**LOCAL VESSELS ADVISORY COMMITTEE**

**Proposed Changes of Navigation Aids for Marking Adamasta Rock**

**Diagram 2 : Proposed Navigational Aids for Marking Adamasta Rock**

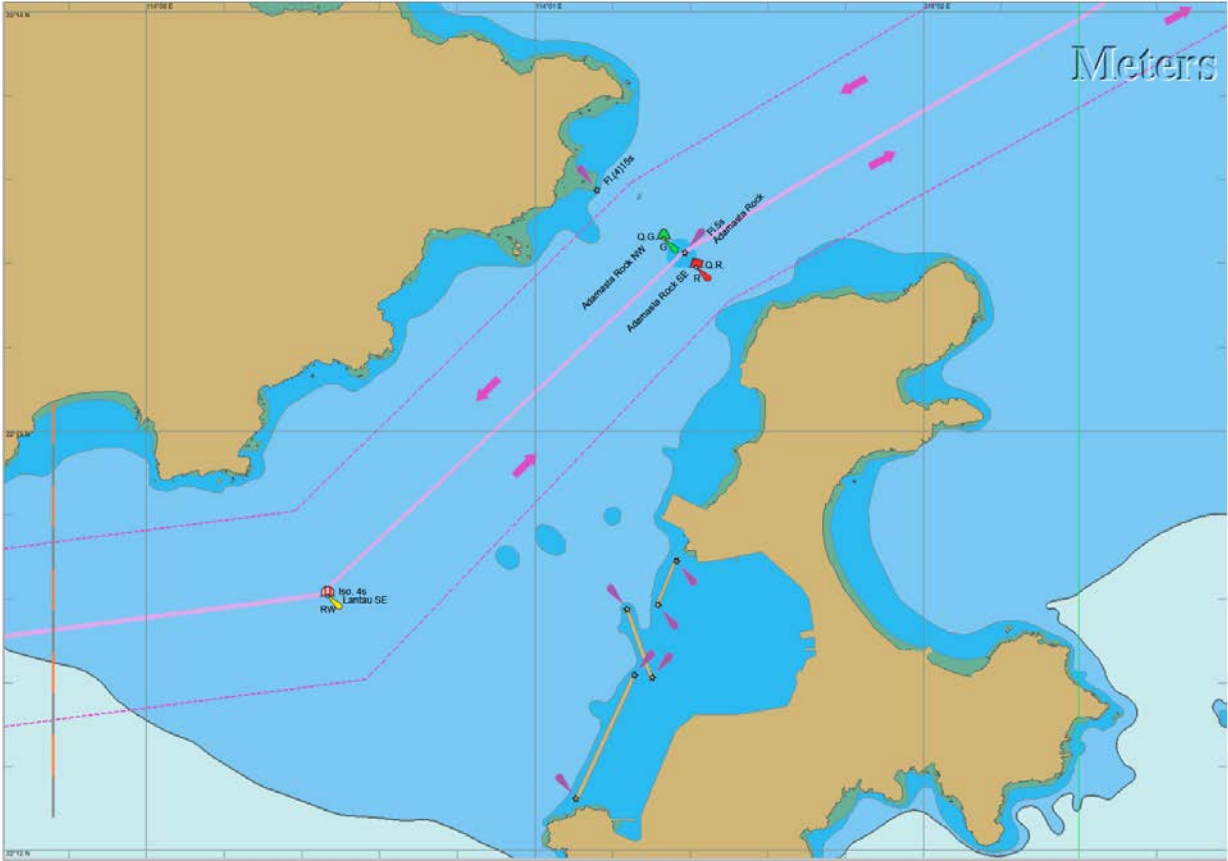
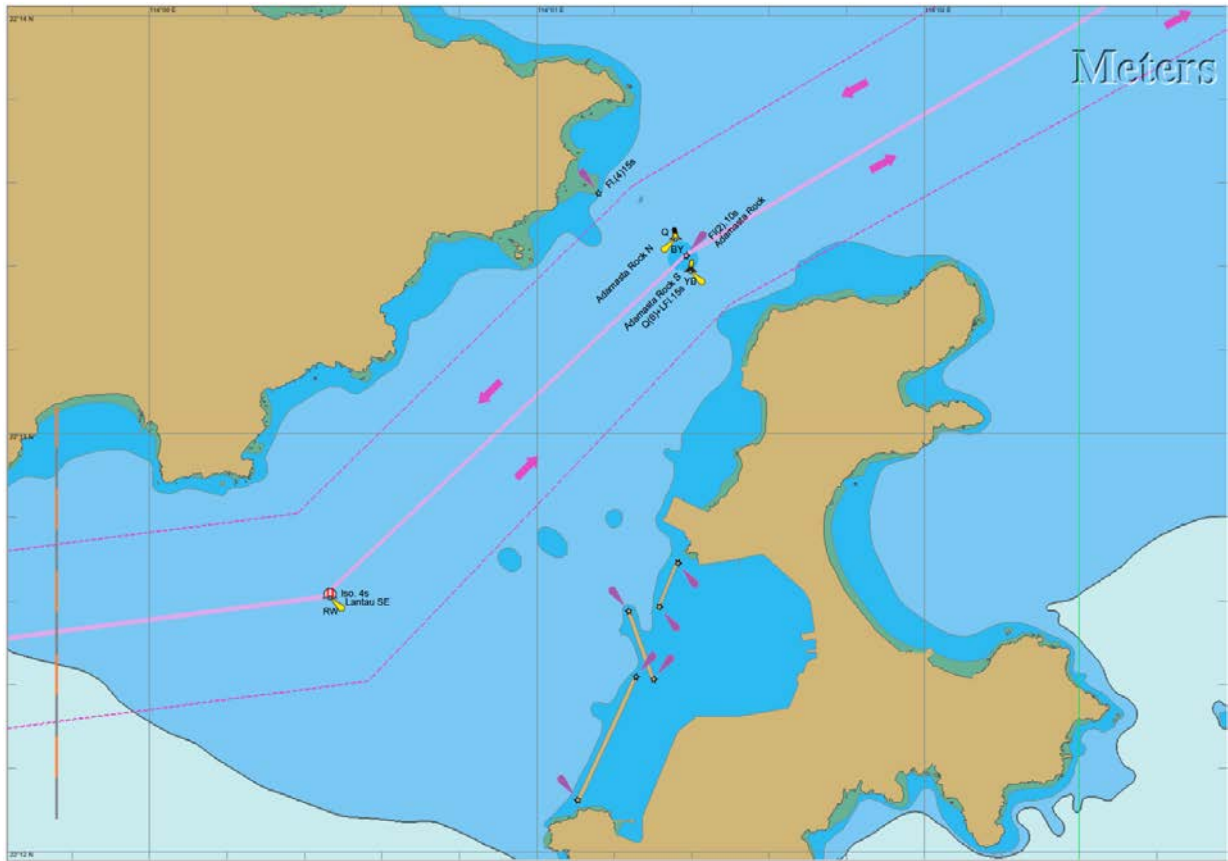
- (i) replacing two existing lateral buoys, currently marking the boundaries of the shoal around Adamasta Rock, by two cardinal buoys at nearby locations (i.e. the northern and southern extremities of the Adamasta Rock shoal) as shown in Diagram 2 below; and
- (ii) changing the light character of the beacon at Adamasta Rock from "Single-flashing" to "Group-flashing (2)", and painting the beacon with black and red horizontal bands.

3. An internal review on the existing navigational aids was conducted for identifying improvements to navigational safety around Adamasta Rock. It is noted that the green conical shape buoy and the red can shape buoy are presented as a pair of lateral buoys laid at the extremities of the Adamasta Rock shoal of about 200 metres apart. As there is a perception that a pair of lateral marks, i.e. the green and red buoys, are laid to mark the two sides of a waterway, mariners who are not familiar with the Conventional Direction of

Buoyage at the Adamasta Channel may consider to travel between the two buoys, in case that they are also not aware of the existence / meaning of the light beacon at Adamasta Rock.

4. Taking consideration of the above findings, the review proposed to replace the existing two lateral buoys by two cardinal buoys<sup>2</sup> at nearby locations, i.e. a cardinal buoy with northern top mark at position of Latitude 22° 13.47' North, Longitude 114° 01.36' East (in WGS 84 Datum) and a cardinal buoy with southern top mark at position of Latitude 22° 13.38' North, Longitude 114° 01.39' East (in WGS 84 Datum), where are the northern and southern extremities of the Adamasta Rock shoal. The light characters of the proposed northern and southern cardinal buoys are "Quick-flashing" and "Quick-flashing (6) followed by a long-flash" respectively. Given the distance between these two buoys is about 200 metres apart, it is also proposed to indicate more clearly the isolated danger characteristic of the beacon at Adamasta Rock by changing the light character of the beacon to "Group-flashing (2)", and painting the beacon with black and red horizontal bands. The proposed navigational aids for marking Adamasta rock are shown in Diagram 2 below.
